**ADDENDUM No. 1
DOCUMENT 00 91 13-A**

**PROJECT: RENOVATION OF DISTRICT 2 WELCOME CENTERS, IN
COAHOMA & DESOTO COUNTIES**

**PROJECT NUMBER: BWO-2162-14(002) / 503757-303000
BWO-2199-17(003) / 503757-304000**

DISTRICT TWO WELCOME CENTER RENOVATIONS
COAHOMA, DESOTO

COAHOMA WELCOME CENTER FLOOR PLAN

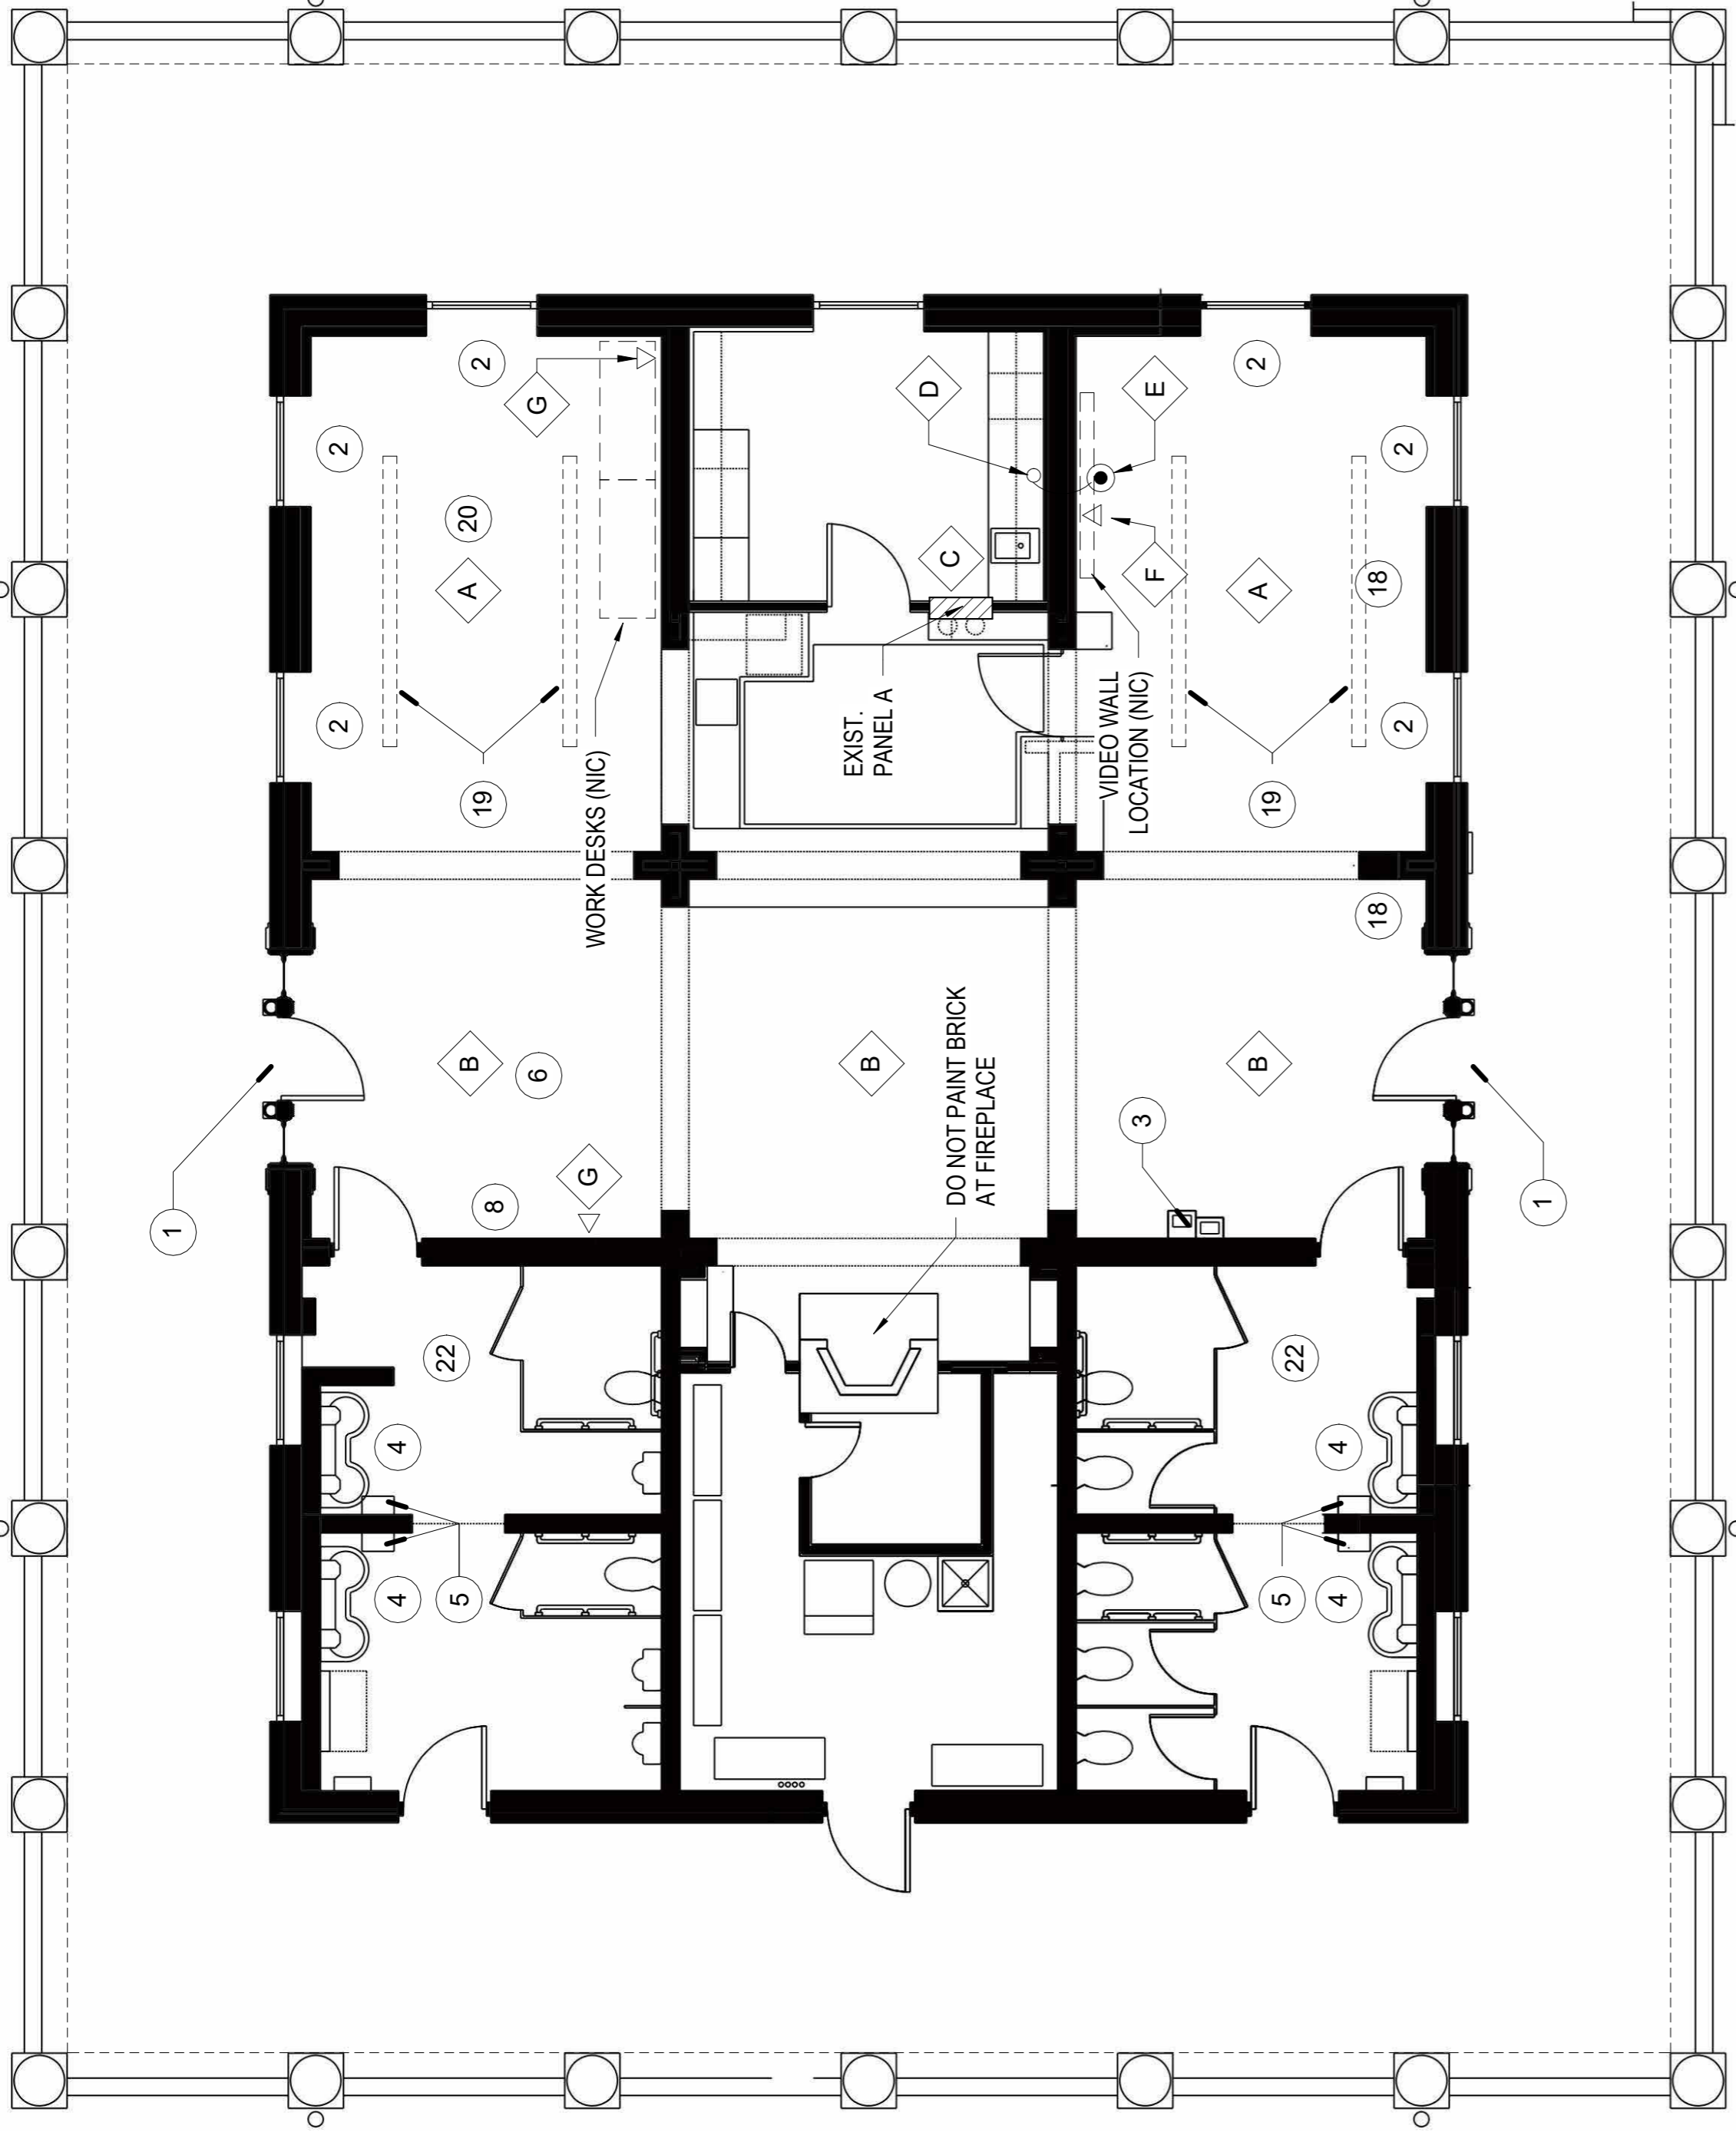
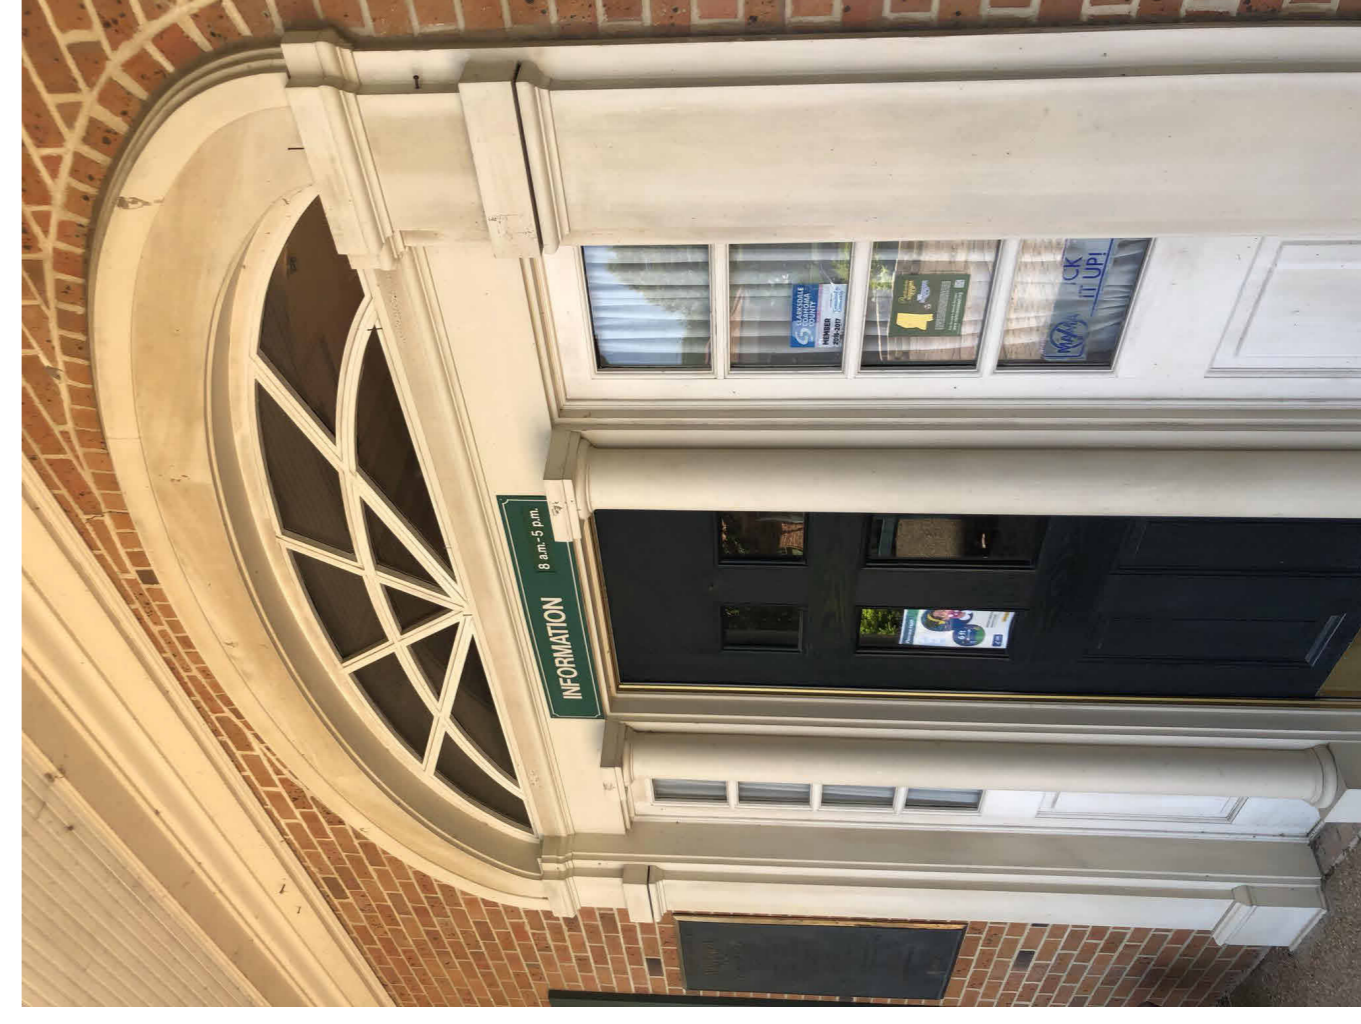
- A. Added Sheet No. 1 – Sheet Index
- B. Sheet No. 2, Coahoma Notes 1,3,4,5,6,7,9,10,13,22 revised 10-4-24, see revisions.
- C. Sheet No. 2, Coahoma Notes – Note 17 – delete the existing note and replace with **“Install two (2) pet waste stations, to be supplied by Owner. Dig a post hole 24 inches deep, install post in concrete, install waste can on post, 6 inches off ground, install dispenser and sign on post. Follow the manufacturer's installation instructions.**
